Response to Lead Local Flood Authority Comments

Land East of Claydon Road, Cropredy

Application No. 23/00977/OUT

ICP SUDS Mean Annual Flood

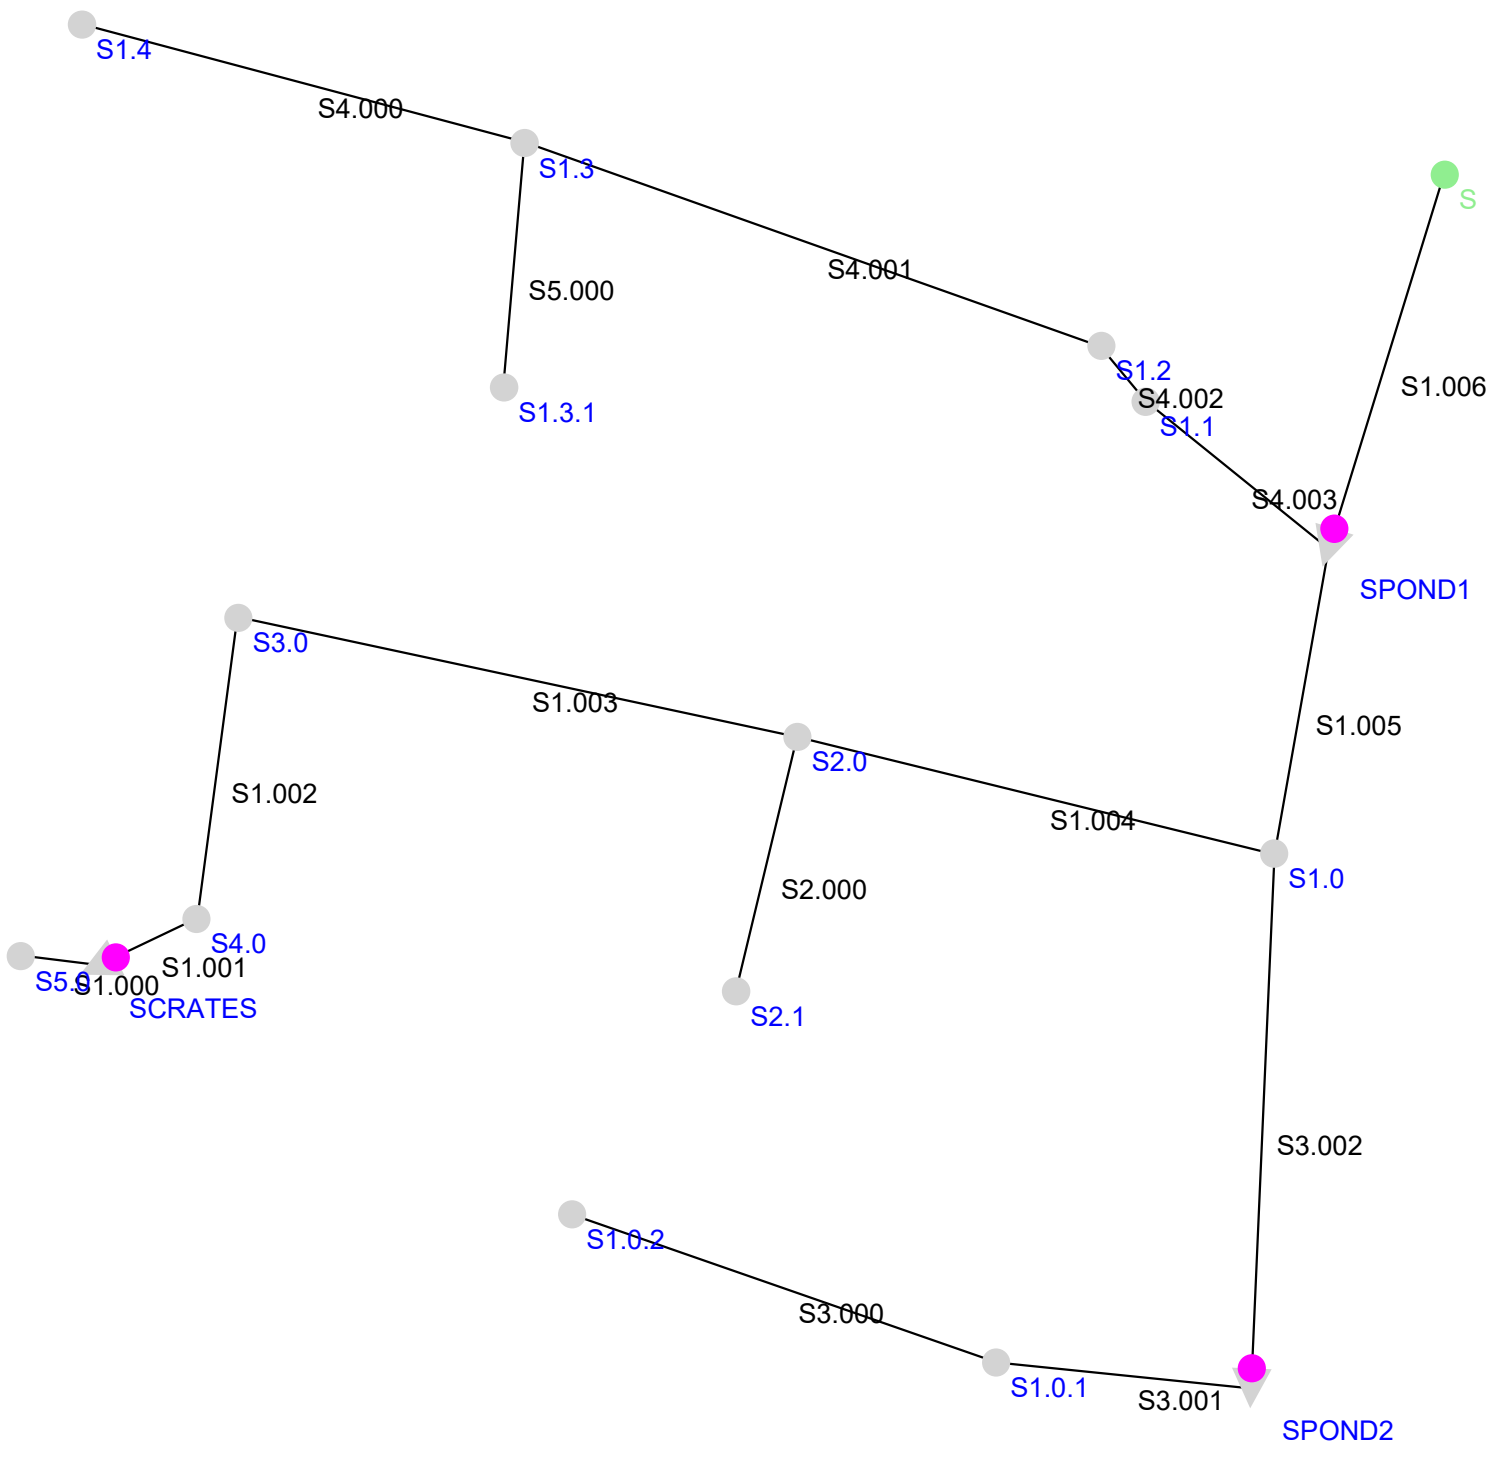
- 2.4 *[LLFA]: Provide greenfield run off calculations. The final discharge rate from the development should be based on QBAR or 2l/s/ha whichever is greater.*

- 2.5 Greenfield run-off rate calculations have been included at Appendix C and confirm a QBAR value of 21.8 l/s.
- 2.6 The site measures approximately 5ha in area 2 l/s/ha to the site area gives a discharge rate of 10.0 l/s.

DRAWING TITLE
**RED AND BLUE LINE
LOCATION PLAN**

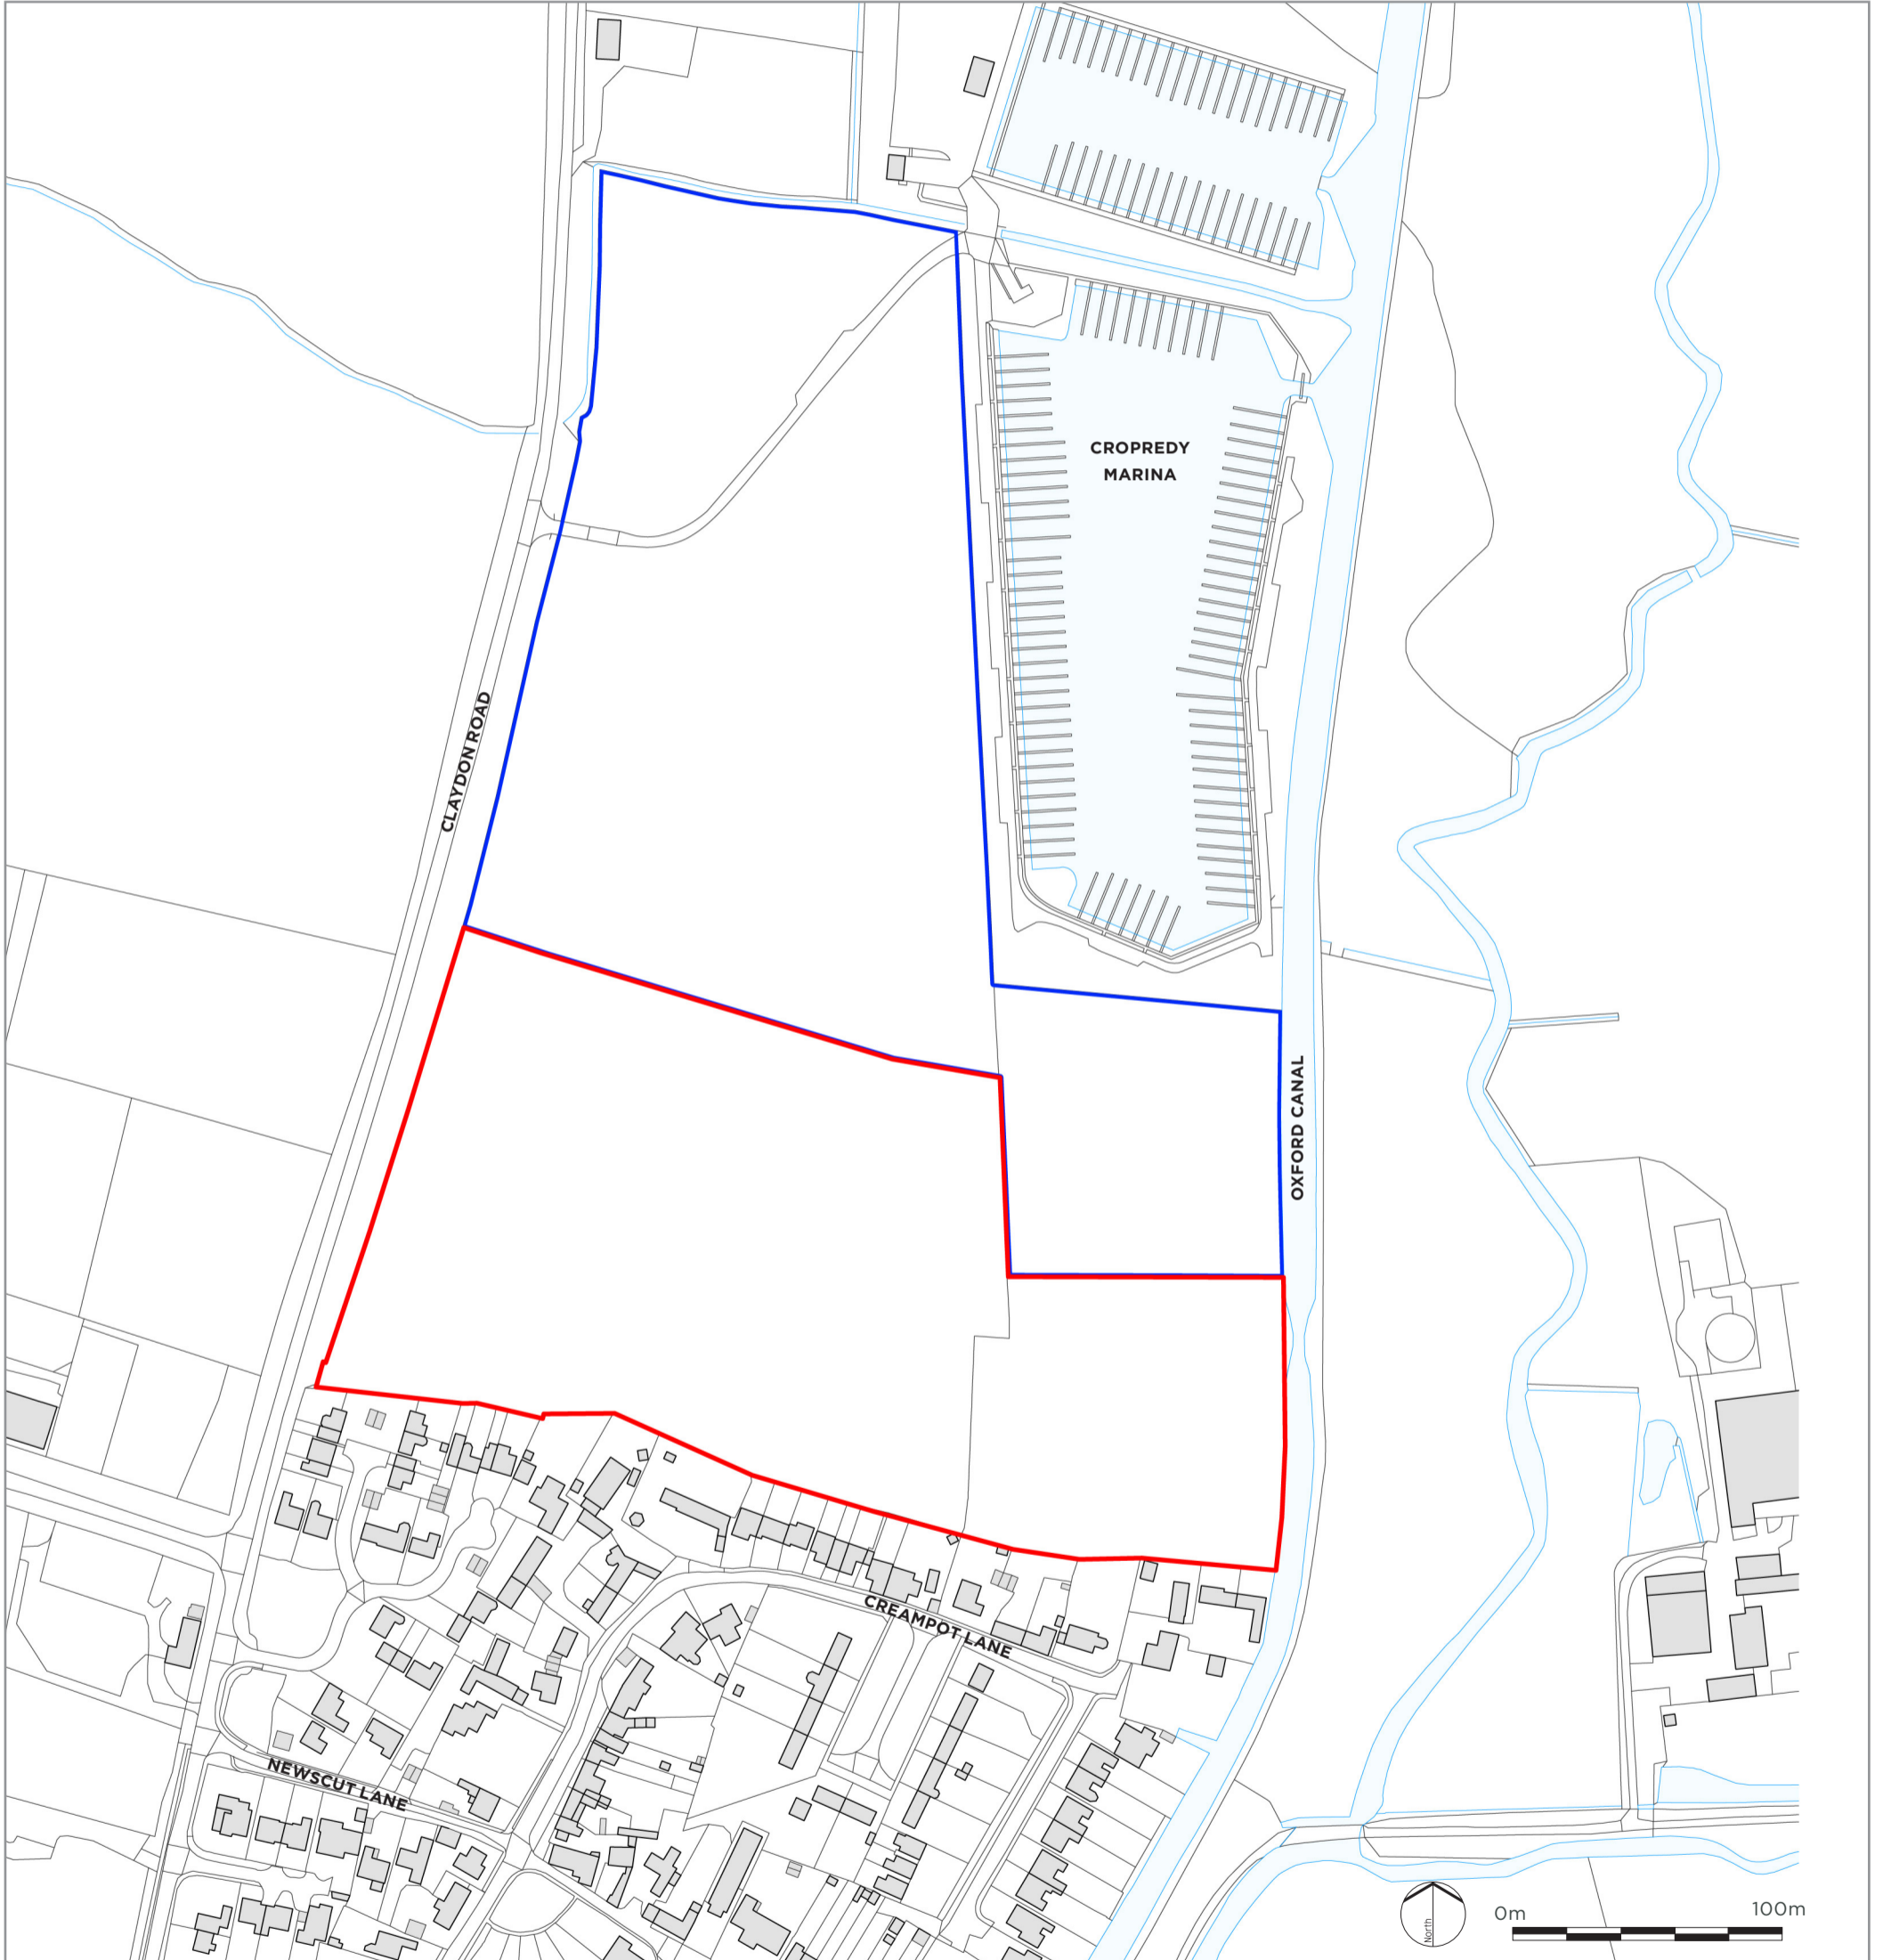
- 2.9 *[LLFA]: The outfall is shown to be outside the site boundary, consent to be provided from the relevant party to make drainage connection to the existing ditch. Should the ditch be located within the Applications land ownership, a title plan needs to be provided to illustrate this.*
- 2.10 An updated site location plan has been included at Appendix E which shows the extent of land controlled by Obsidian Strategic Asset Management outlined in blue. This plan confirms that whilst the drainage outfall falls outside of the application red line boundary, it is located within the ownership boundary and therefore does not cross third party land.
